Our Reference: UP25201  
Council Reference: A006973028

04 June 2026

**COUNCIL REFERENCE:** A006973028  
**PROPOSED APPLICATION:** DEVELOPMENT APPLICATION FOR A MATERIAL CHANGE OF USE FOR ROOMING ACCOMMODATION  
**PROPERTY ADDRESS:** 8 PONSONBY STREET, ANNERLEY QLD 4103  
**REAL PROPERTY DESCRIPTION:** LOT 10 // RP902779

Ultimate Planning Solutions act on behalf of the applicant in addressing the matters raised by Brisbane City Council (B.C.C) through the information request dated 13 April 2026. This response relates specifically to development application A006973028.

***Figure 1: Site photograph confirming all existing landscaping to be retained as part of this development application.***

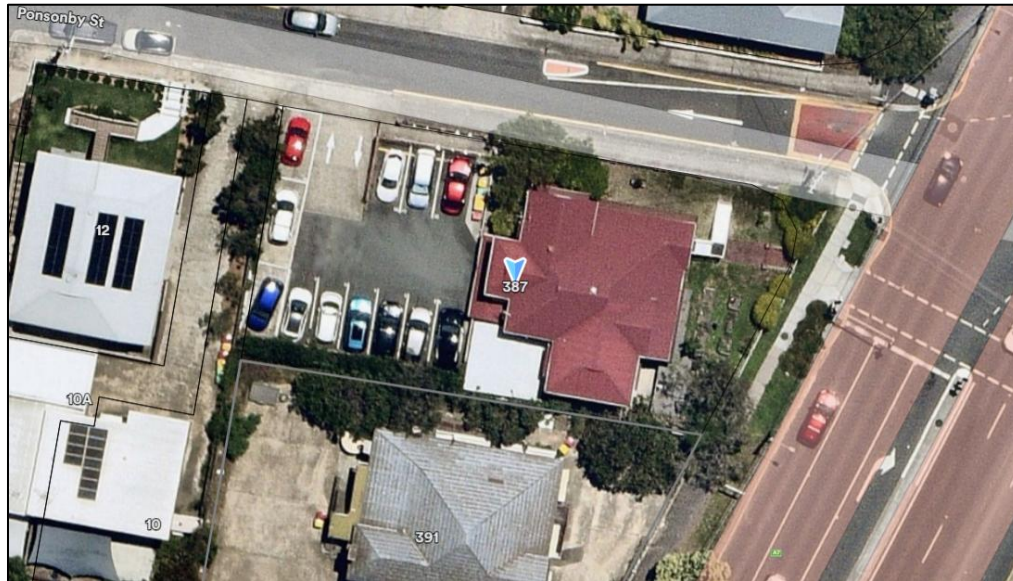
5. *The proposal does not include enough information to allow Council to assess the proposal against the detailed provisions of the planning scheme, including the Multiple dwelling code PO28, PO29 and PO30 and the Landscape works code.*

*A landscape concept plan prepared by a qualified Landscape Architect is required. A well resolved landscape concept plan will likely result in the conditioning of the works for private certification.*

- a) *Provide a landscape concept plan indicating a scale bar and linear line dimensions (such as the width of garden beds), to allow for Council Officers to measure electronically.*

- i. *the extent, function and character of areas to be landscaped, finished surface levels and gradients, and details of walls and fencing.*
  - ii. *the proposed deep planting zones with both dimensions and calculations for the percentage of total site area being met, noting that there are to be no obstructions, including built form/roof overhang, fencing, pathways and engineering infrastructure within the deep planting zones.*

- iii. *Proposed mulch deep planting zones with shade trees.*
  - iv. *Demonstrate how the landscape side screening along the boundaries will be able to mitigate the impacts of the built form and to ensure that adequate landscape screening can be achieved to contribute to the local character, amenity and microclimate for the development and adjoining residences.*

The applicant does not consider that a Landscape Concept Plan is required in this instance.

The proposal does not involve any fundamental structural or locational changes to the existing building. The works are limited primarily to the internal fitout and use of the existing building, with no material change to the building footprint, setbacks, built form presentation or existing landscaped areas.

As the existing building form and site layout are being retained, the existing landscape character of the site will also be maintained, including the existing landscaping elements and landscaped interfaces to adjoining properties.

On this basis, the proposal does not create any new or additional landscape impacts requiring a detailed Landscape Concept Plan. The existing landscaped setting will continue to contribute to the local character, amenity and presentation of the site.
